# Service Bulletin

**SUBJECT:** Service Update for Inventory and Customer Vehicles  
Fuel Pipe Quick Connect Replacement  
Expires with Base Warranty

**MODELS:** 2012 Chevrolet Sonic  
Equipped with 1.4L Turbo Engine (LUV) and 6-Speed Manual Transmission

2784062

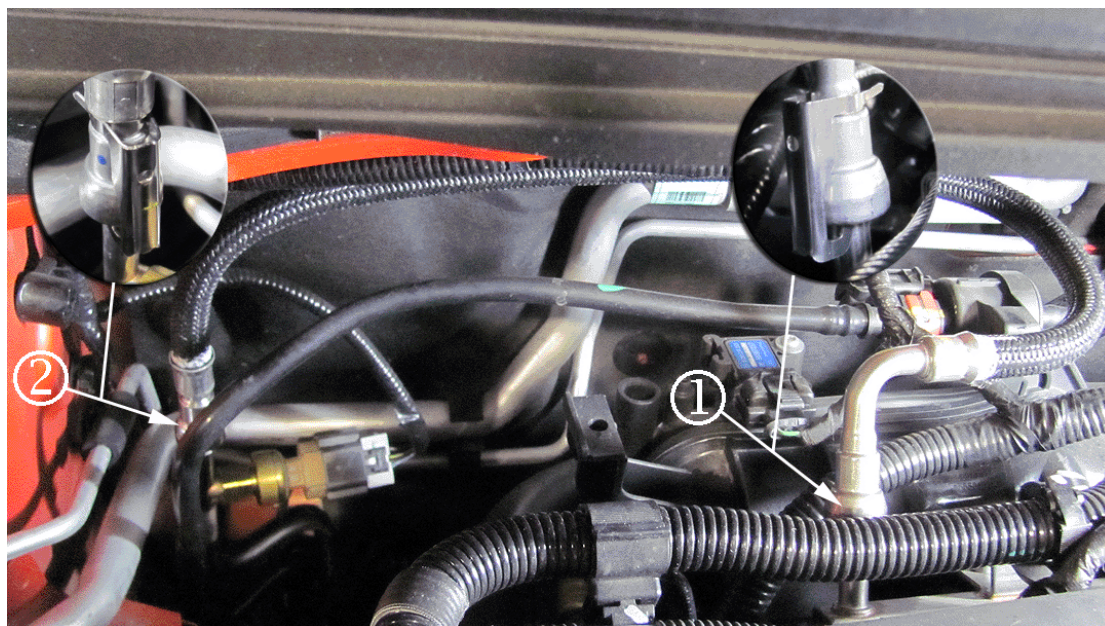
This bulletin provides a service procedure to replace the fuel pipe and quick connect on **certain** 2012 model year Sonic vehicles equipped with 1.4L Turbo engine (LUV) and 6-speed manual transmission. In a high speed front crash test involving a Sonic vehicle with similar content, the nylon fuel feed pipe quick connect fractured and released a small amount of fuel after the crashed vehicle was rolled 90 to 180 degrees. The small amount of fuel did not exceed the amount allowed in the federal safety standard for fuel system integrity in a crash.

4. Connect the new front fuel feed pipe connector to the fuel injector rail (1) and the fuel feed pipe (2). Refer to *Plastic Collar Quick Connect Fitting Service* in SI.
5. Install the fuel feed pipe clip retainers at the quick connect ends of the fuel feed pipe as shown in the illustration.
